March 11, 2015

On behalf of Green Meadow, LLC and Charah, Inc., HDR provides the enclosed Addendum 2 regarding the permit application entitled:

*Permit Application, Colon Mine Site, Structural Fill, Charah, Inc., Sanford, North Carolina.*  
Prepared for Charah, Inc. Prepared by HDR Inc. November 2014. DIN 22354.

The purpose of this addendum is to relate proposed enhancement to certain design and engineering aspects of the proposed project, specifically regarding the liner system groundwater separation, stormwater and leachate management systems, and the water quality monitoring plan. In addition this addendum clarifies that a minimum five foot groundwater separation buffer is maintained in the design. The following provides a brief summary of the sections and revisions in this addendum.

Subcell Divider Berm Areas

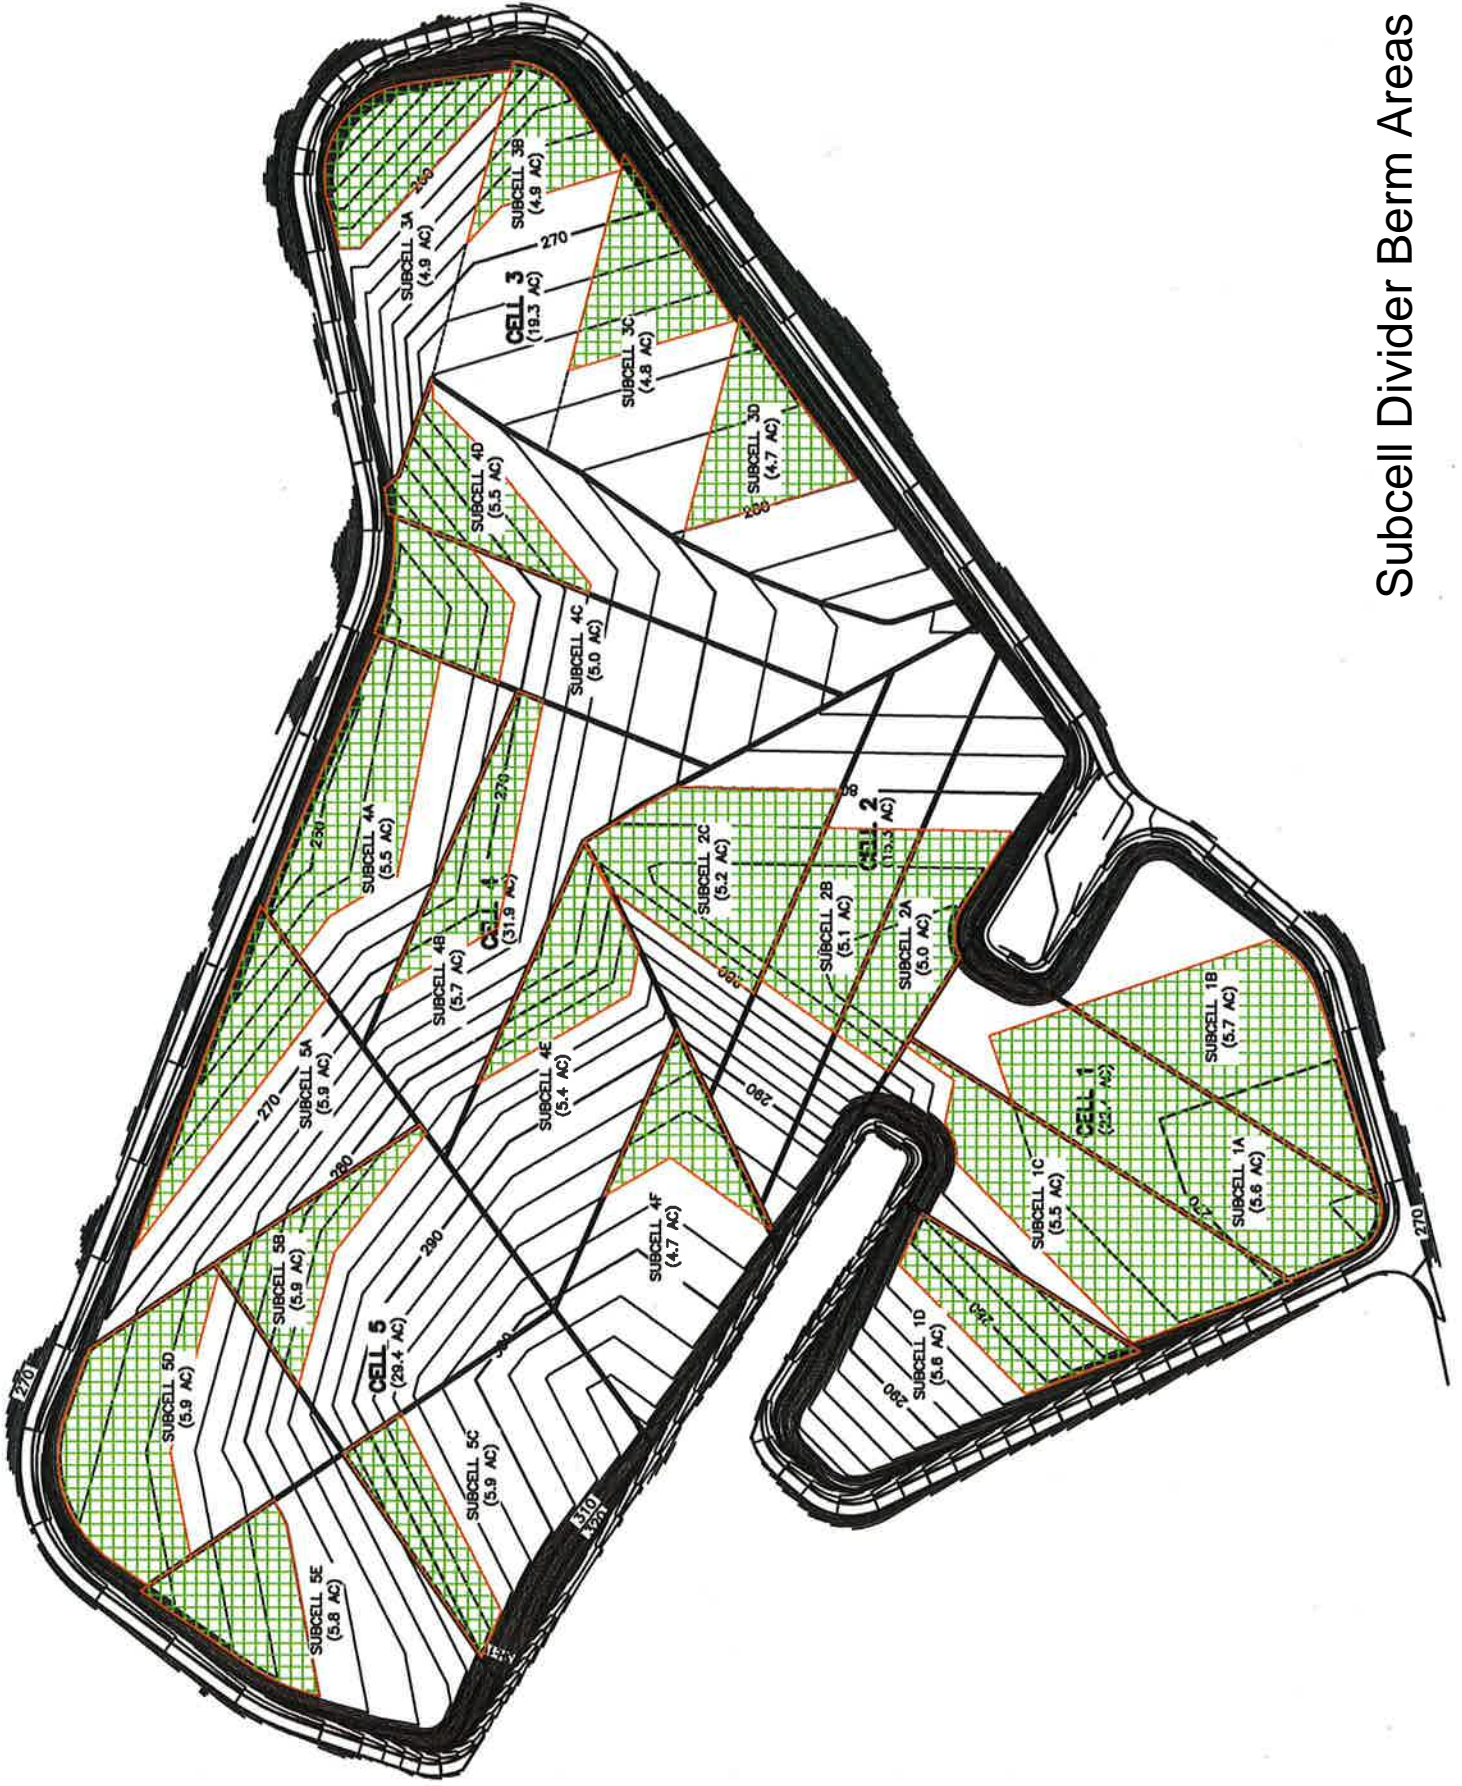
All individual subcells can contain the design storm event.  
 1 ft should be added to the Berm Height to maintain freeboard.

Figure 6 (revised)

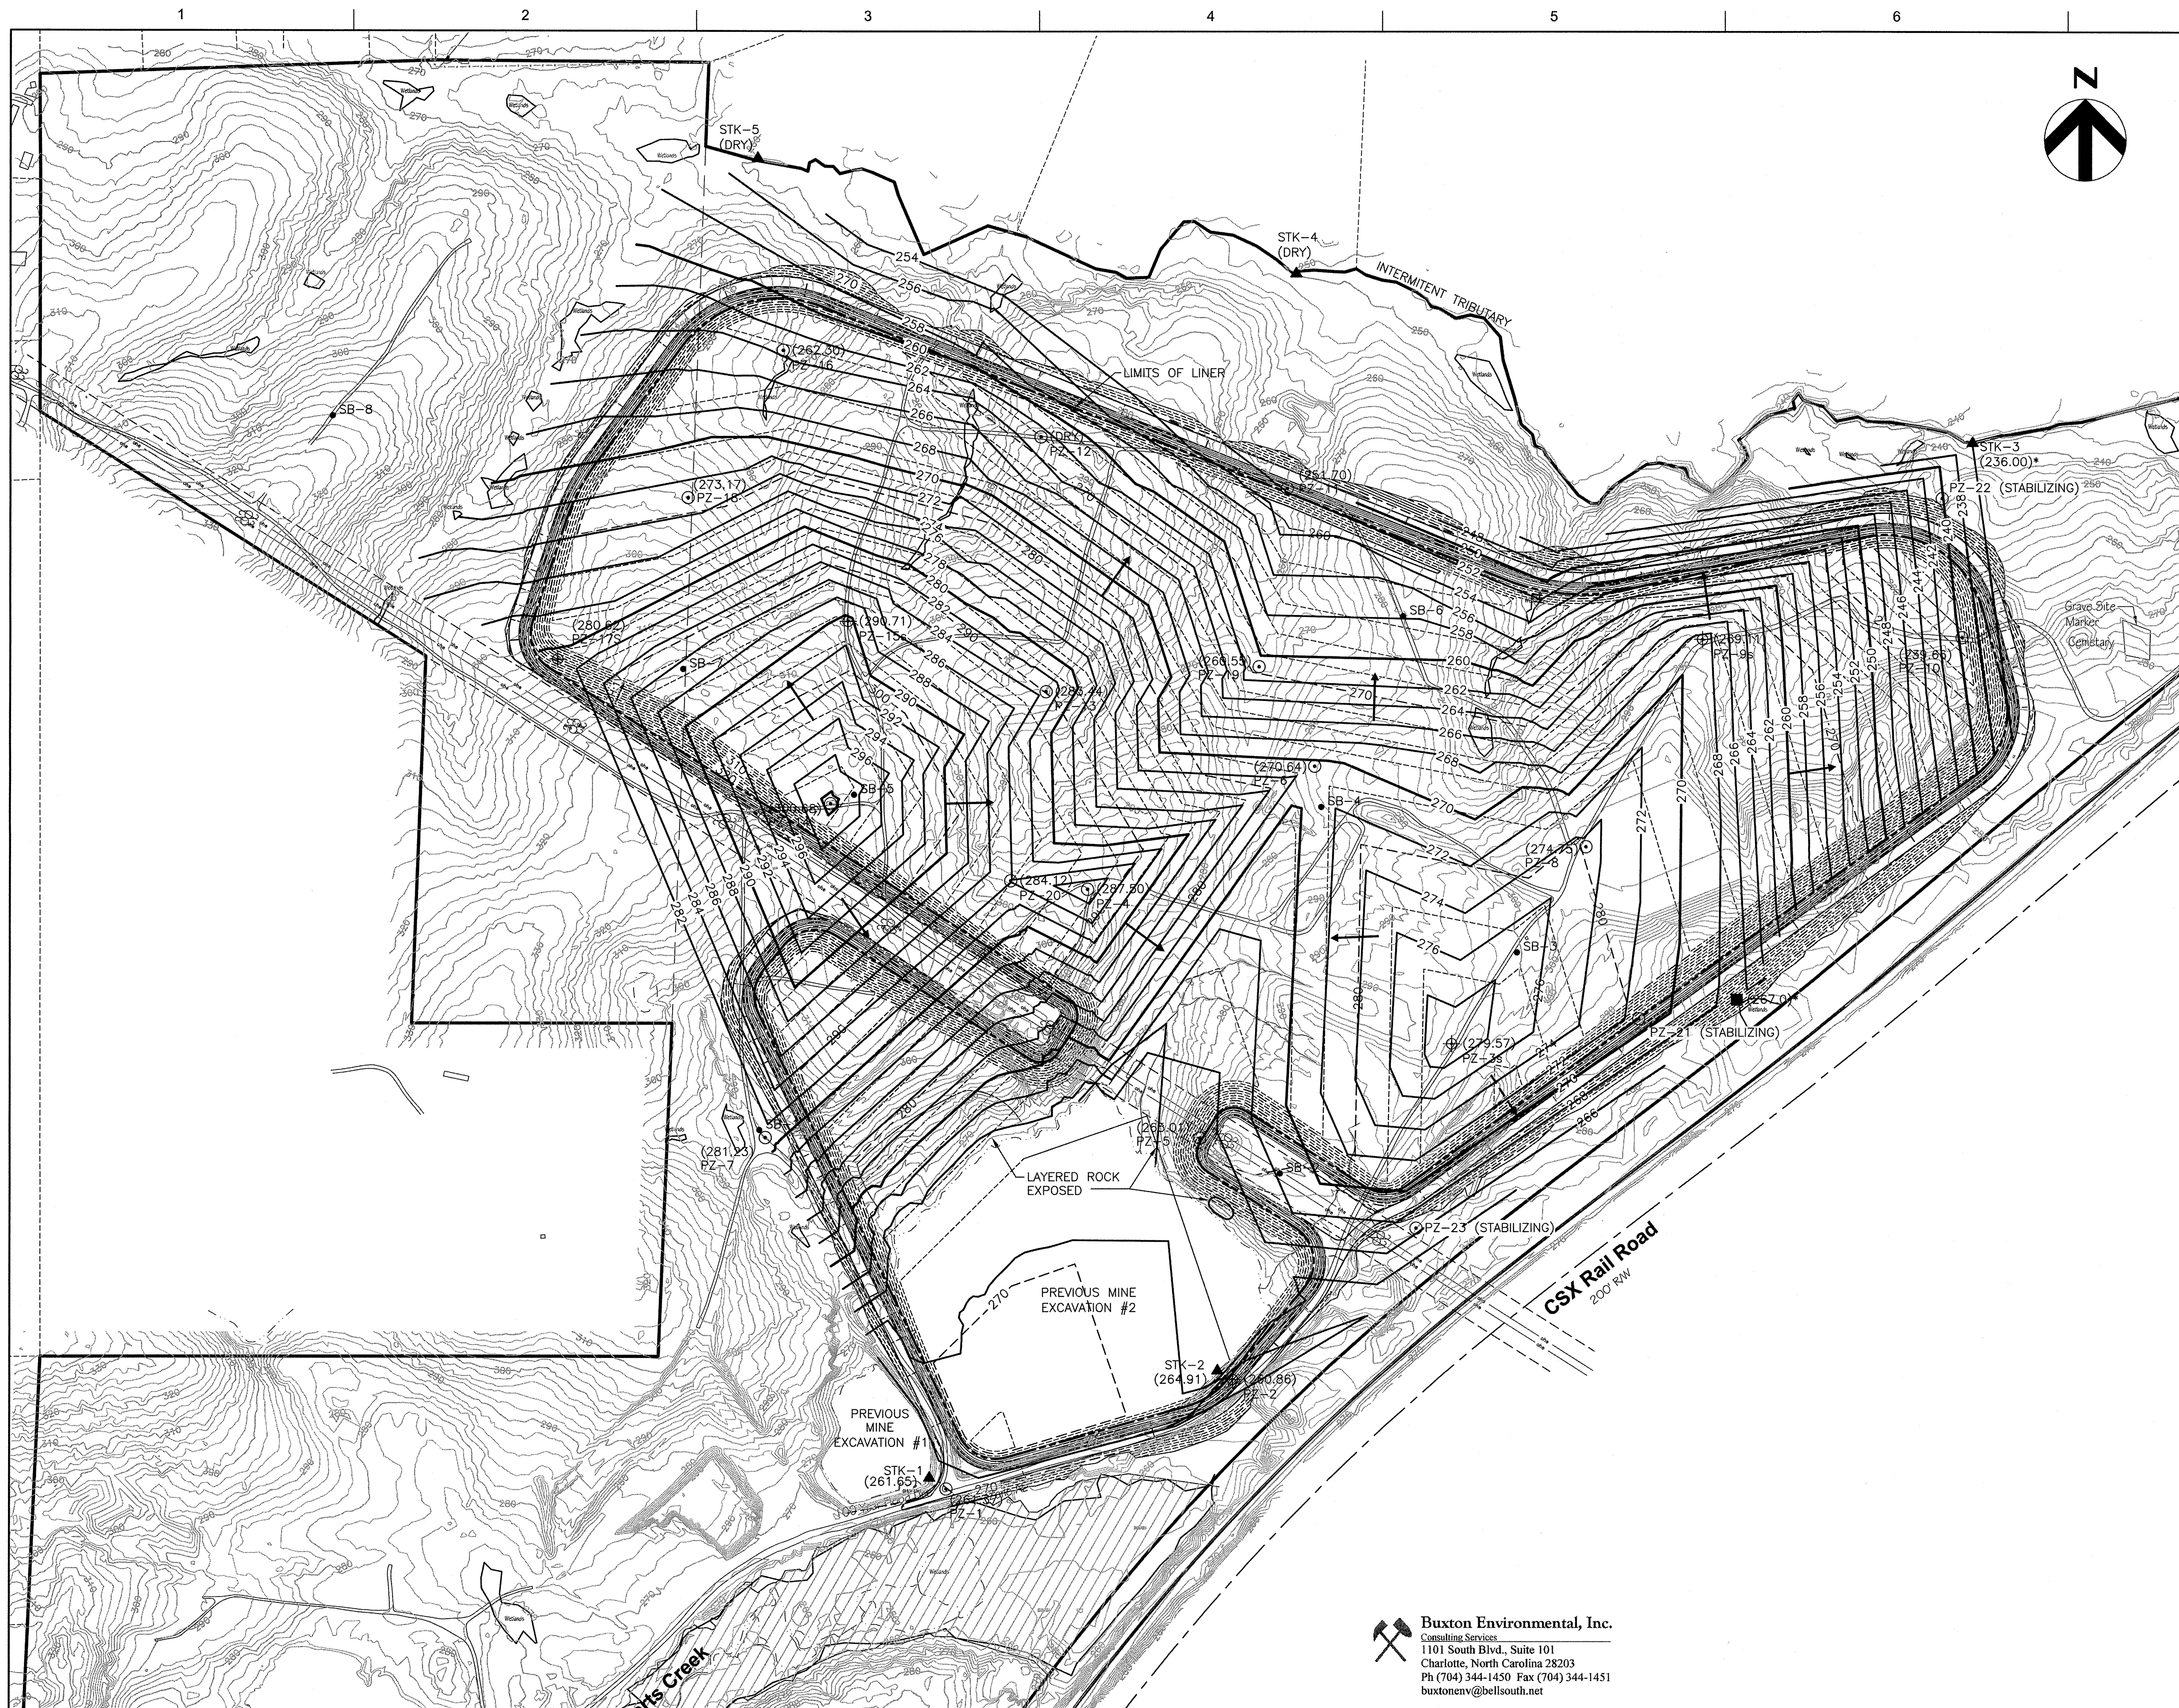
The Plan is revised to reflect the inclusion of 8 background monitoring events, statistical evaluation, and reference to analysis for Appendix III constituents.

The Seasonal High - Shallow & Intermediate Groundwater Potentiometric Map with Proposed Top of Liner Grades is provided in Figure 6. [\(Revised\)](#)
